Abbey Road Improvements – RSA Stage 3 Designer Responses

For Coventry City Council

ABR-HWY-RSA3-DOC-SM-0001-Rev-01

STAGE 3 ROAD SAFETY AUDIT
LONDON ROAD / ABBEY ROAD SIGNALISED JUNCTION

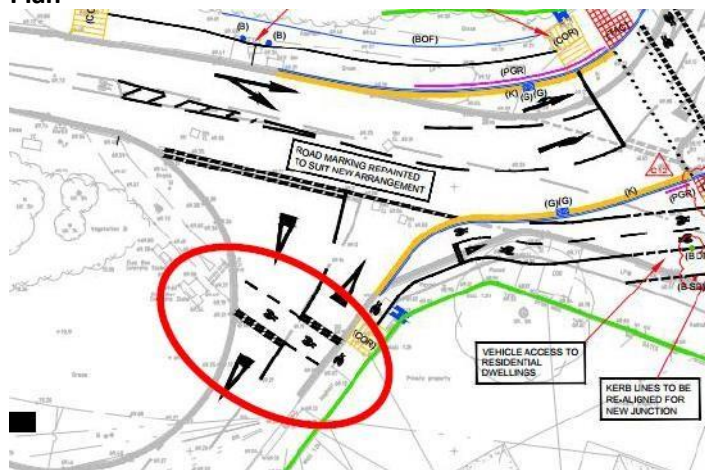
3.1 Problem Dedicated right turn lane.	
Summary The dedicated right-turn lane (from London Road into Abbey Road) layout is not sufficient as it is not long or wide enough to accommodate an average sized car. Subsequently, vehicles will have to wait half on/half off. Vehicles will over hang the inside running lane and this significantly increases the likelihood of vehicle to vehicle swipe type injury collisions.	
Plan 	
Recommendation Reconfigure the lining so that the dedicated right-turn lane is sufficient to accommodate right-turners. This will reduce the likelihood of side swipe personal injury collisions.	Recommendation Accepted Y/N
	Y
Designer Response The lining has been increased as much as the site constraints allow. See the attached plan within Appendix A.

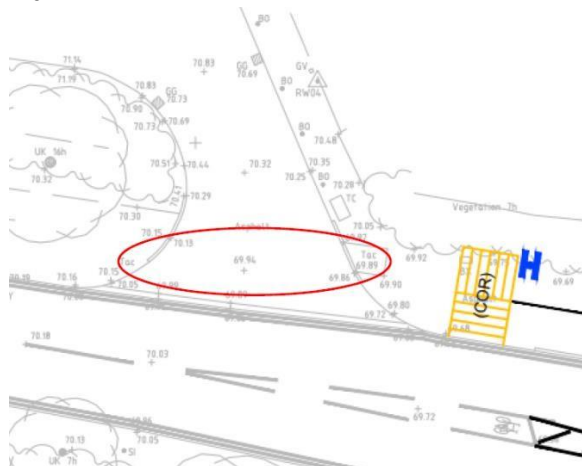
Separate cycle crossing facilities have been provided across Abbey Road and London Road (northern arm). However, signals are only provided on the adjacent pedestrian crossings and these are either not visible or not in the direct line of sight of cyclists waiting at the stop lines. Therefore, cyclists using these facilities are unable to see/observe instructions on whether it is safe to cross or not. This significantly increases the likelihood of vehicle to cyclist type personal injury collisions.

Separate cycle signals should be provided on both cycle crossing facilities to ensure that cyclists can see/observe whether it is safe to cross or not. This will significantly reduce the likelihood of vehicle to cyclist type personal injury collisions.

This has been passed to Yunex (signal designers) for review and rectifications.

2.1 Problem: Bus stop Location

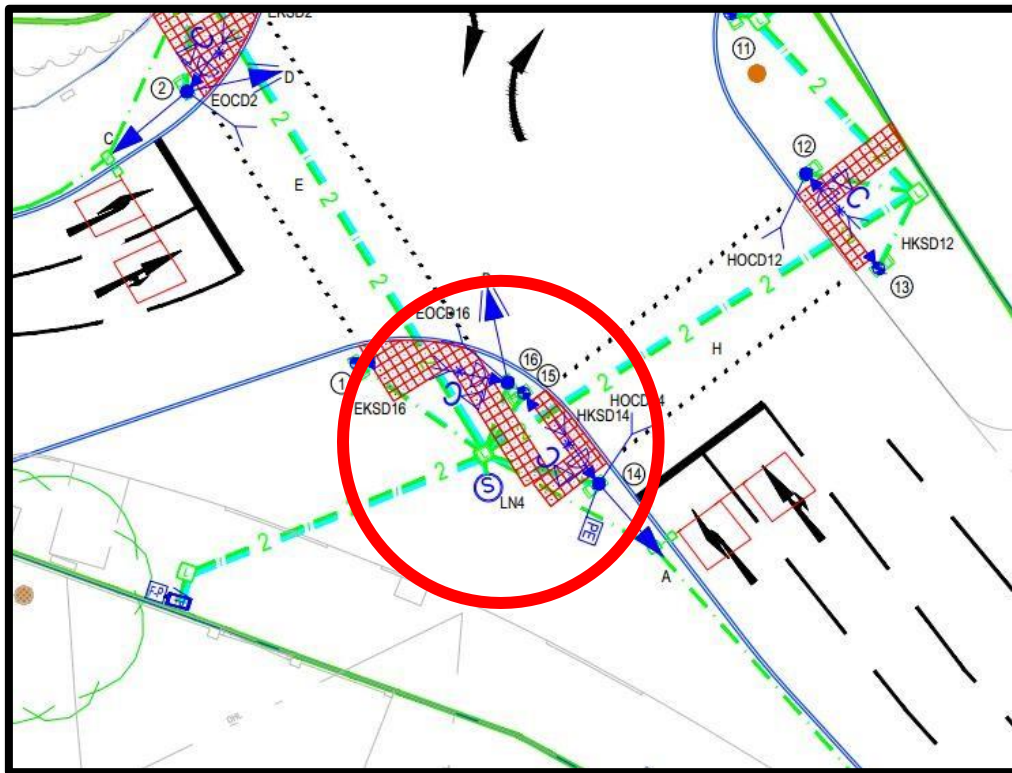
The bus stop relocation is on the approach to the proposed signalised junction, and in particular the signal heads. Buses waiting within the bus stop will significantly reduce the conspicuity of the signal heads (for vehicles on the approach from north to south)-west to south-east) and this significantly increases the risk of vehicle to vehicle and vehicle to pedestrian type personal injury collisions.

The designer's response in regards to stopping distances is noted, however, the audit team still regard the location of the bus stop may result in conspicuity problems. Relocating the bus stop may significantly reduce the likelihood of vehicle-to-vehicle and vehicle to pedestrian type collisions.

The Audit Team are satisfied that this item has been resolved.

2.3 Problem: Cycleway Connectivity

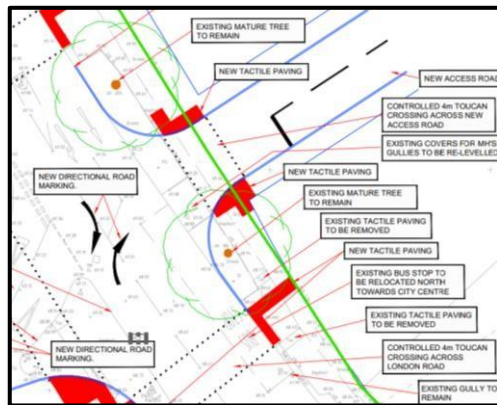
Although the updated drawings have demonstrated the typical footway/ cycleway design, with pedestrians furthest away from the road; there are still gaps in the cycleway connectivity throughout the scheme. This includes providing Toucans with no associated cycle routes on the footway. This may result in cyclist confusion and this may increase the likelihood of cyclist to pedestrian personal injury collisions.

Ensure the proposed cycleway infrastructure is fully connected to the existing cycleway infrastructure. This will significantly reduce the likelihood of cyclist to pedestrian type personal injury collisions.

The Audit Team are not satisfied that this item has been resolved. Therefore, this item remains outstanding.

2.4 Problem: Service covers - throughout scheme

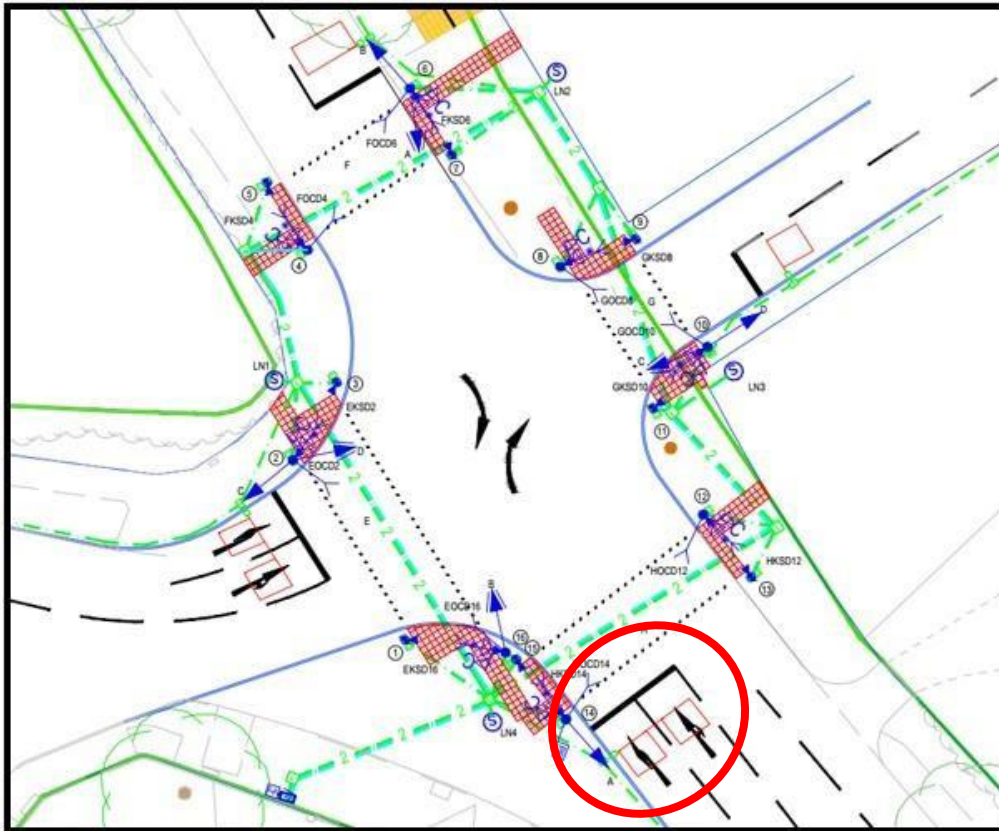
The existing covers are to be re-levelled but will remain in situ. This location is where a high proportion of vehicles will be turning out of the new access into London Road. Having service covers at/on a corner increases the risk of vehicles skidding and also increases the likelihood of the service cover failing and becoming a maintenance issue. This increases the likelihood of vehicle to vehicle type personal injury collisions.

There are service covers on the proposed cycleway and the designs do not indicate that they will be made cycle friendly. Service covers can make cycling unsafe, particularly in adverse weather conditions; and significantly increases the likelihood of cyclist personal injury.

Examine existing service covers and make the service covers cycle friendly so they do not cause any road safety hazards.

The Audit Team are satisfied that this item has been resolved.

3.1 **Problem:** Dedicated right-turn lane

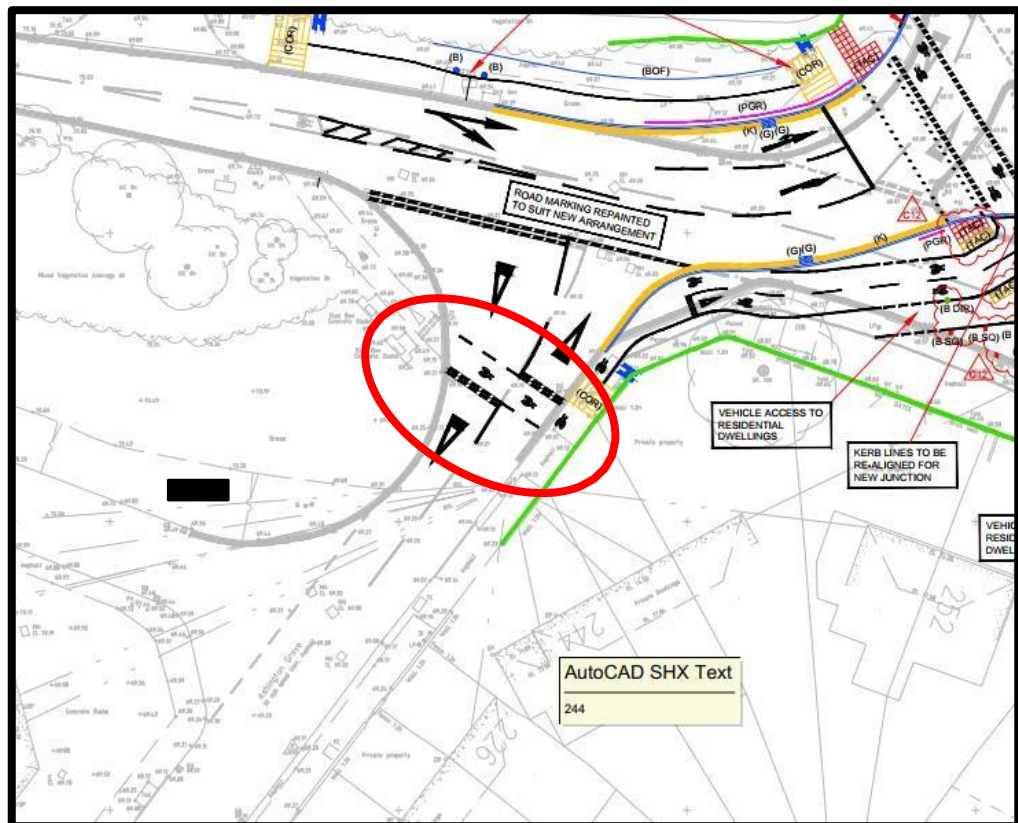
*The dedicated right-turn lane *from London Road into Abbey Road) layout is not sufficient as it is not long or wide enough to accommodate an average sized car. Subsequently, vehicles will have to wait half on / half off. Vehicles will overhang the inside running lane and this significantly increases the likelihood of vehicle-to-vehicle side swipe type personal injury collisions.*

Reconfigure the lining so that the dedicated right-turn lane is sufficient to accommodate right-turners. This will reduce the likelihood of side swipe personal injury collisions.

3.5 Problem: Signals cannot be seen by cyclists

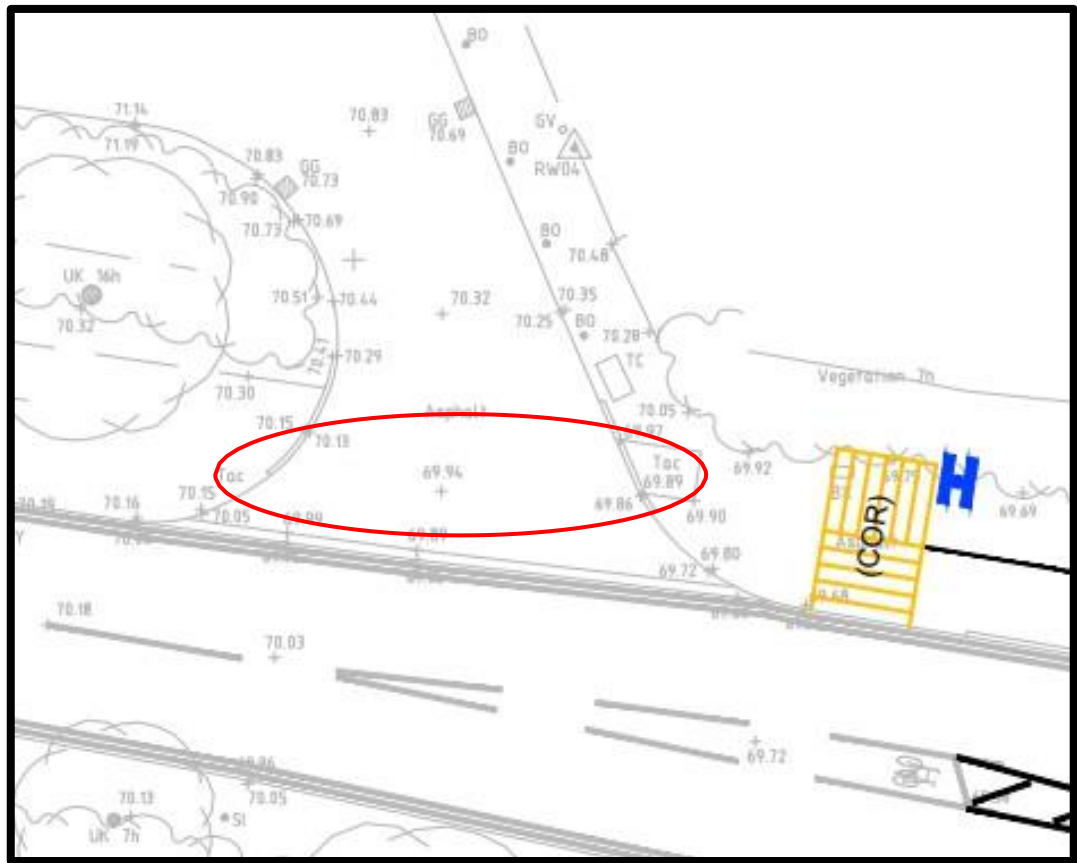
Separate cycle crossing facilities have been provided across Abbey Road and London Road (northern arm). However, signals are only provided on the adjacent pedestrian crossings and these are either not visible or not in the direct line of sight of cyclists waiting at the stop lines. Therefore, cyclists using these facilities are unable to see/observe instructions on whether it is safe to cross or not. This significantly increases the likelihood of vehicle to cyclist type personal injury collisions.

Separate cycle signals should be provided on both cycle crossing facilities to ensure that cyclists can see / observe whether it is safe to cross or not. This will significantly reduce the likelihood of cyclist to vehicle type personal injury collisions. The signals on the pedestrian crossings across Abbey Road and London Road (northern arm) should show pedestrians only.
